Office Action Summary	Application No. 10/749,073	Applicant(s) ALI ET AL.	
	Examiner Milton Nelson, Jr.	Art Unit 3636

DETAILED ACTION

Title: VEHICLE SEAT ASSEMBLY HAVING A VEHICLE SENSING SYSTEM AND REINFORCING INSERTS POSITIONED THEREIN
 Inventor's Name: Ali et al. - Docket No. 04428 (3883.00033)

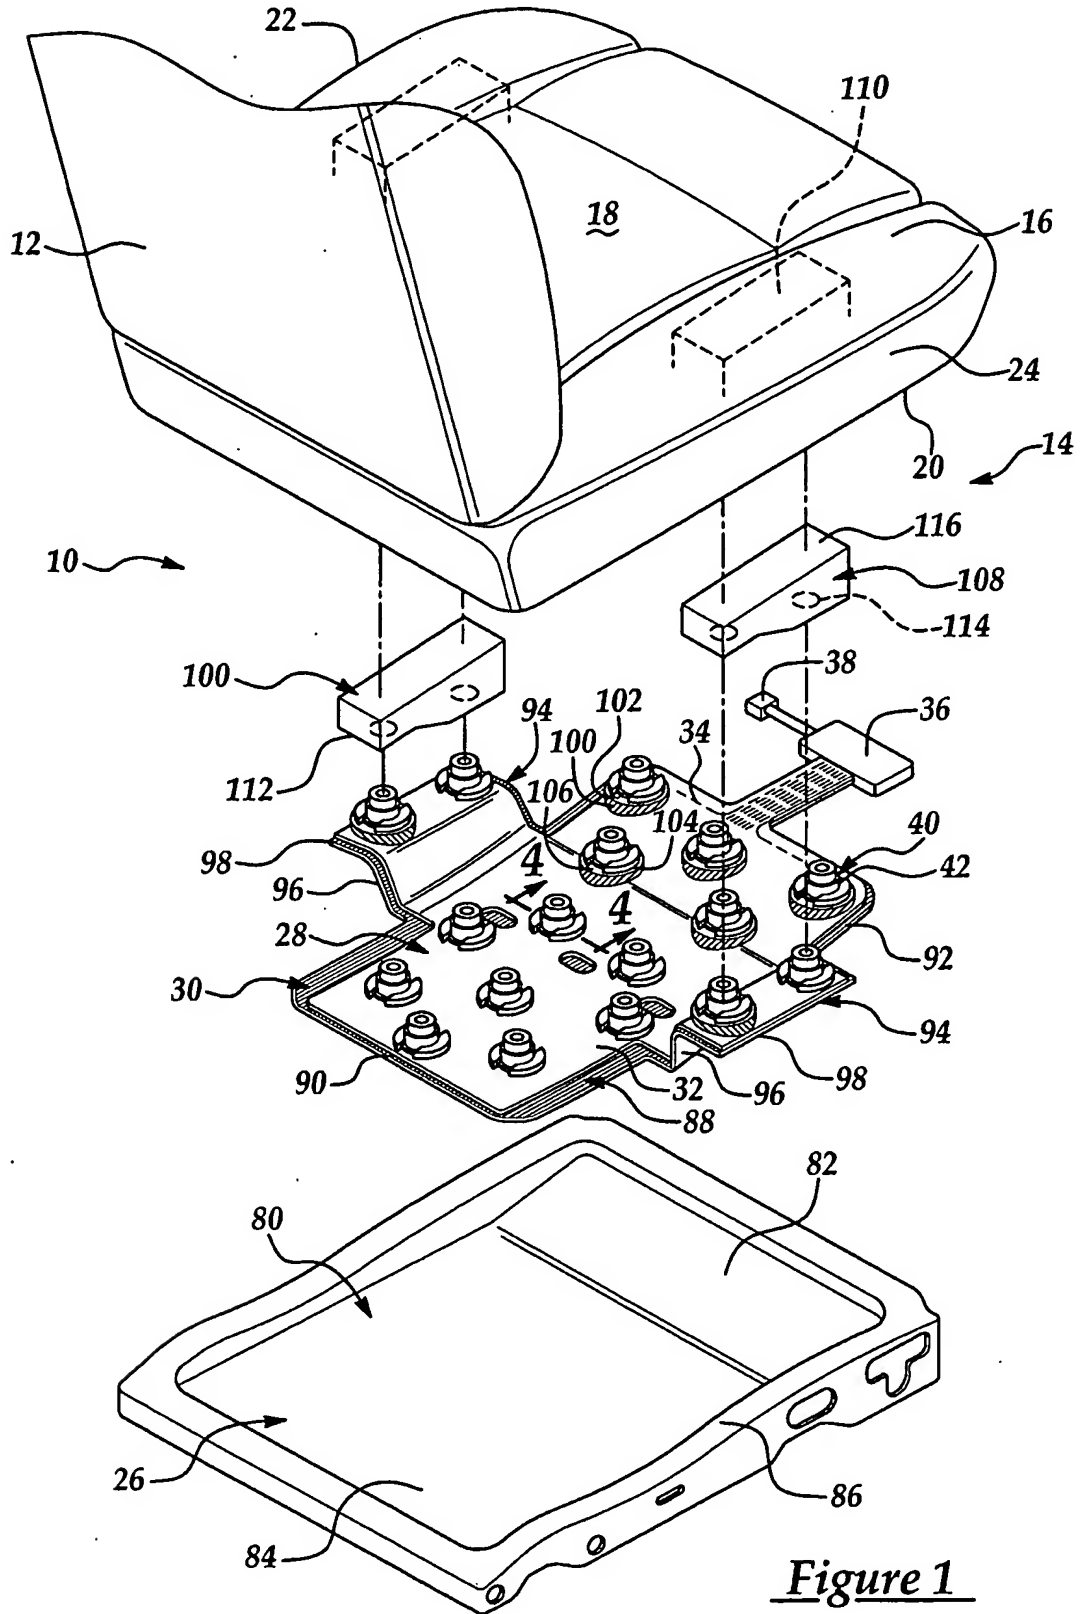
The drawing sheet containing Figure 1 has been objected to as failing to comply with 37 CFR 1.84(p)(4) because reference character "100" has been used to designate both the insert and the pedestal. Corrected drawing sheets in compliance with 37 CFR 1.121(d) are required in reply to the Office action to avoid abandonment of the application. Any amended replacement drawing sheet should include all of the figures appearing on the immediate prior version of the sheet, even if only one figure is being amended. Each drawing sheet submitted after the filing date of an application must be labeled in the top margin as either "Replacement Sheet" or "New Sheet" pursuant to 37 CFR 1.121(d). If the changes are not accepted by the examiner, the applicant will be notified and informed of any required corrective action in the next Office action. The objection to the drawings will not be held in abeyance.

*disapproved
 1/21/06*
